YUCCA MOUNTAIN PROJECT

REVIEW RECORD MEMORANDUM

EXPLORATORY SHAFT FACILITY (ESF) TITLE I DESIGN ACCEPTABILITY ANALYSIS AND COMPARATIVE EVALUATION OF ALTERNATIVE ESF LOCATIONS

FEBRUARY 3, 1989

Figure 1. Isopach maps of Hydrostratigraphic Units below the Repository and Location of Faults

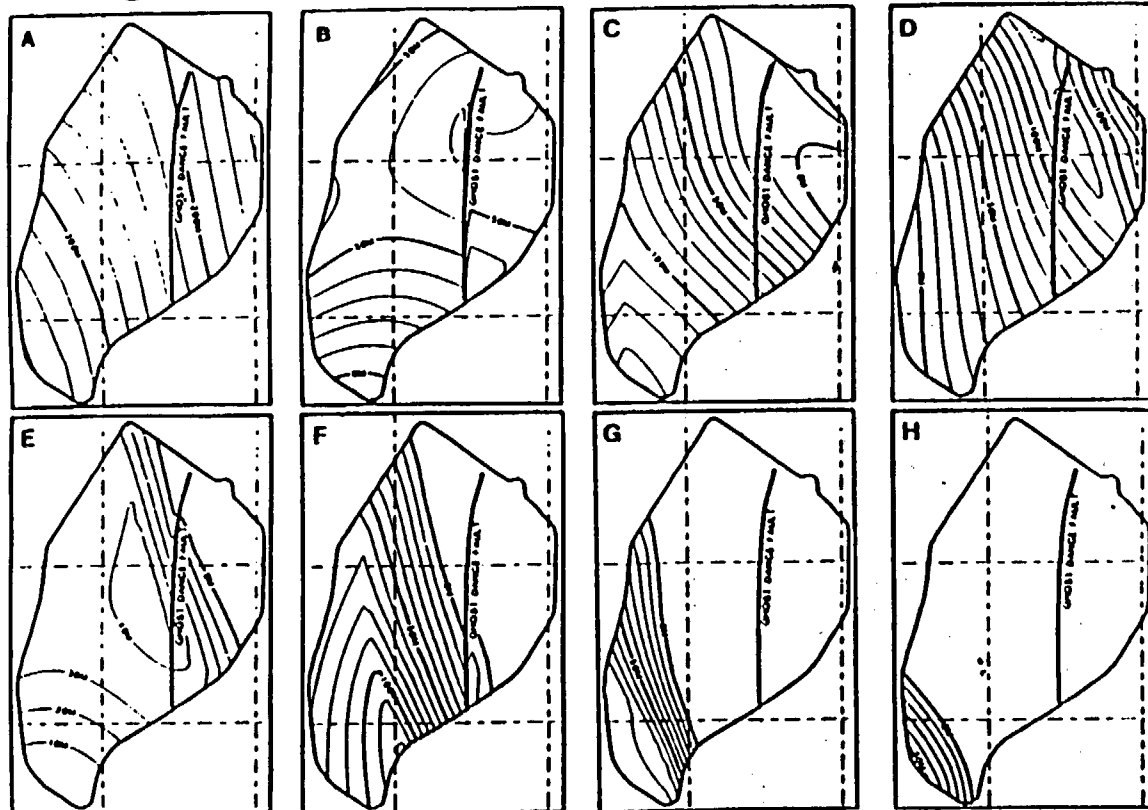
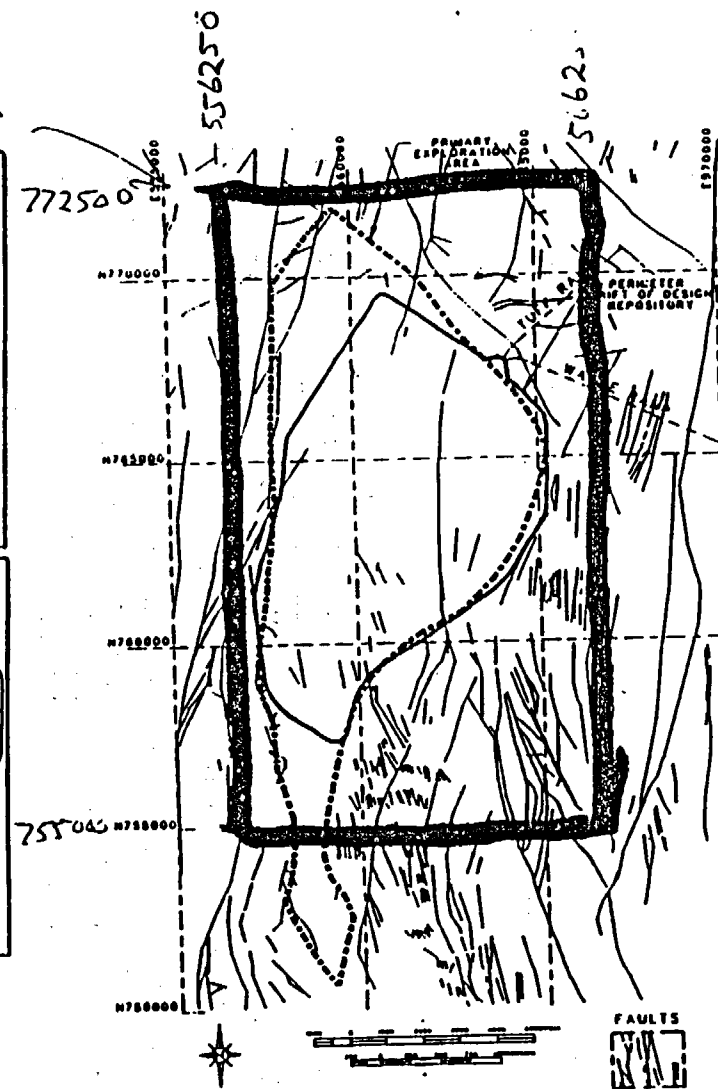
note: These will be replaced with new maps showing thickness
 from repository in field and extending to area of limits on Fault map
